July 27, 2020 · 5:30 pm
Conway Municipal Building

New Single-Family Residence (East House)

1830 Scott Street - Old Conway Design Overlay District

New Single-Family Residence (West House)

FRONT ELEVATION
1/4"=1'-0"

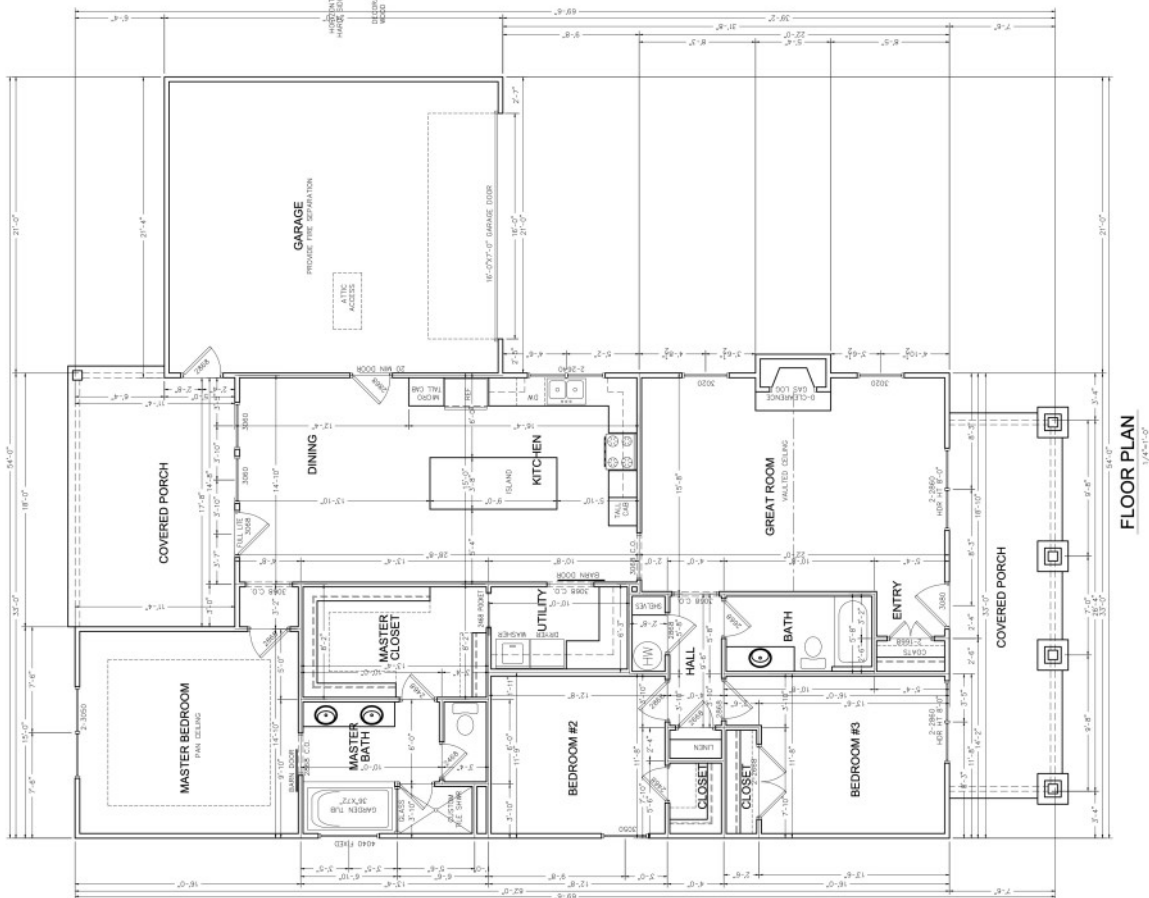
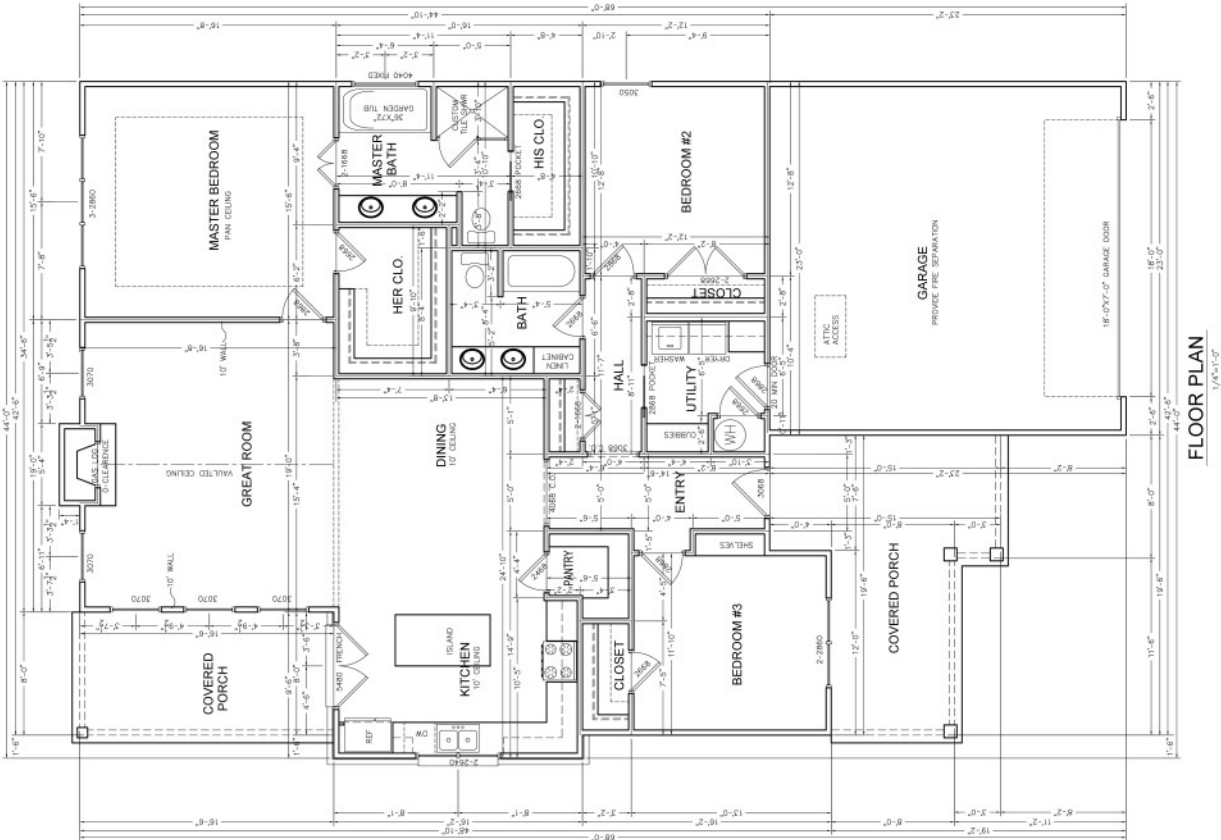
The applicant is proposing the use of brick (foundation) and wood/Hardie board (horizontal siding and flat panel to mimic stucco). These materials are appropriate. Consider removal of the shutters on the upper story window.

1. Consider removal of the shutters on the upper story window.
2. Use of Hardie panel to mimic stucco.

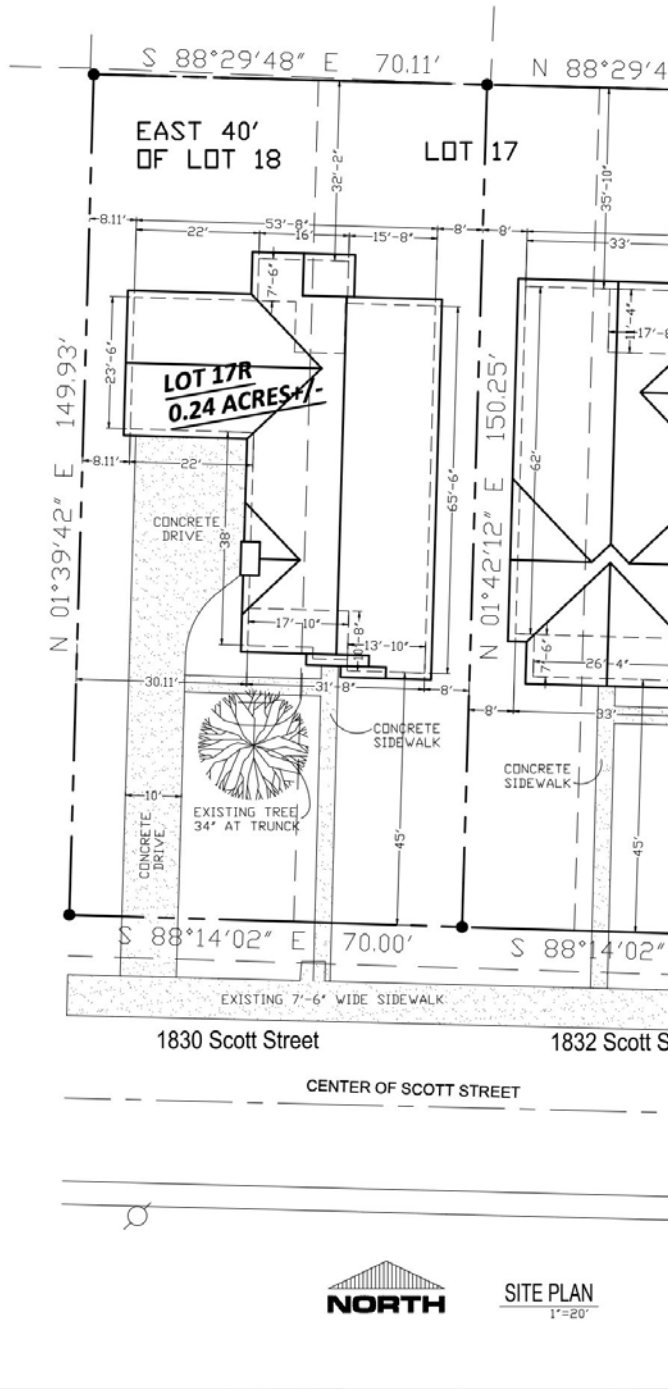
The three tier gable front is not appropriate to the area. Recommend requiring extending the middle tier to extend flush with the bedroom extension.

Recommend requiring the upper gables be composed of one style material (either shakes or horizontal siding) to be more compatible with the surrounding area.

Recommend requiring an additional window on the east façade for bedroom three (at the front of the house).

1. Planting of one canopy tree is required in the front yard.
2. All HVAC and mechanical shall be placed in a manner to prevent from being seen from the street or screened from view.
3. Require an additional window on the east façade for bedroom three (front of the house).
4. Require extending the middle tier gable to extend flush with the bedroom extension on the front of the house.
5. Require the upper gables be composed of one style material (either shakes or horizontal siding) to be more compatible with the surrounding area.
6. Require revised drawings for approval by the Planning Director prior to issuance of Certificate of Appropriateness.

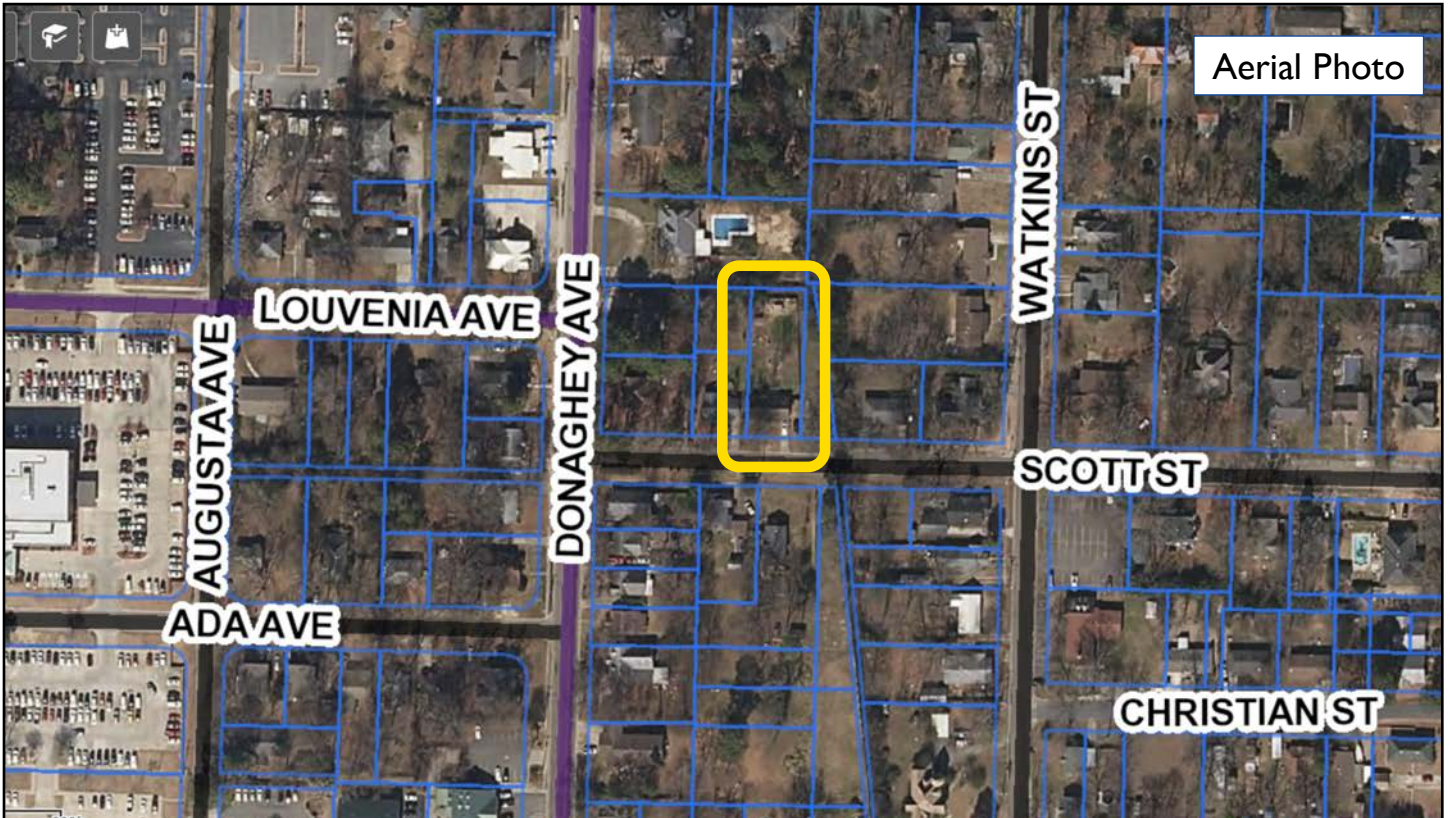
The fence is a 6' solid wood privacy fence with a cap rail and is setback 13' from the front façade. There are very few fences in the immediate area. The fence constructed is now a prominent feature visible from the street which does not fit the historical character of the neighborhood and is therefore not appropriate in its current form.

- 1) Modify the front leg of the fence to 4' tall and add a 2' tall, 50% opaque lattice-like extension.
- 2) Require additional landscaping in front of the fence including a minimum of 2 canopy trees and multiple shrubs.

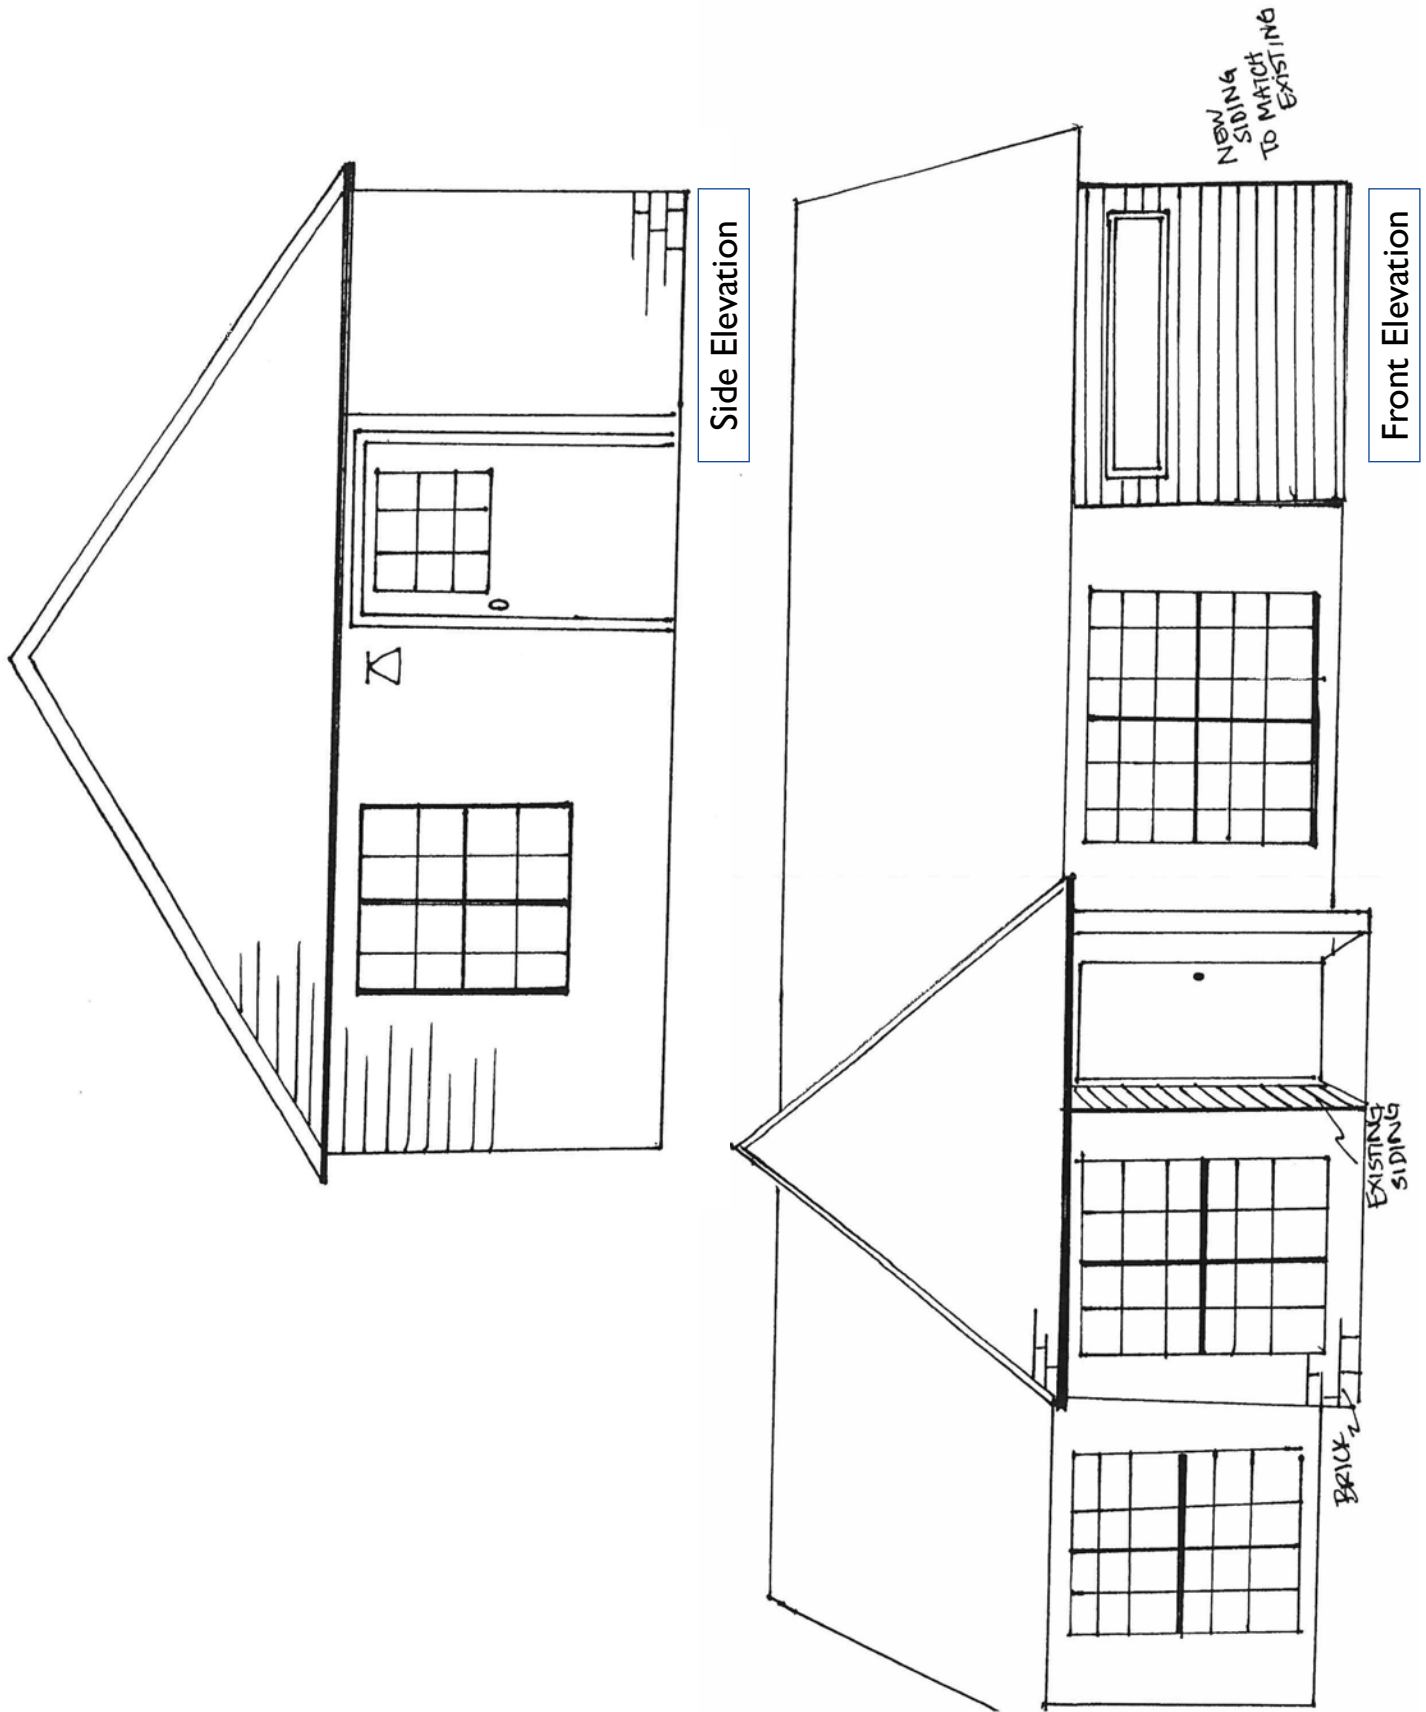
The applicant is proposing a horizontally oriented window on the front façade of the proposed enclosure. The proposed window orientation is inconsistent with the existing openings on the front of the house. Staff has included a condition of approval that the proposed window be replaced with one that is consistent in height to width ratio to the other front windows.

1. The enclosed carport shall be constructed with wood or Hardie board, as appropriate.
2. HVAC equipment be placed in a manner to minimize its visibility from the street.
3. The proposed window design shall be replaced with a window matching the height to width ratio of the existing windows on the front façade of the house.
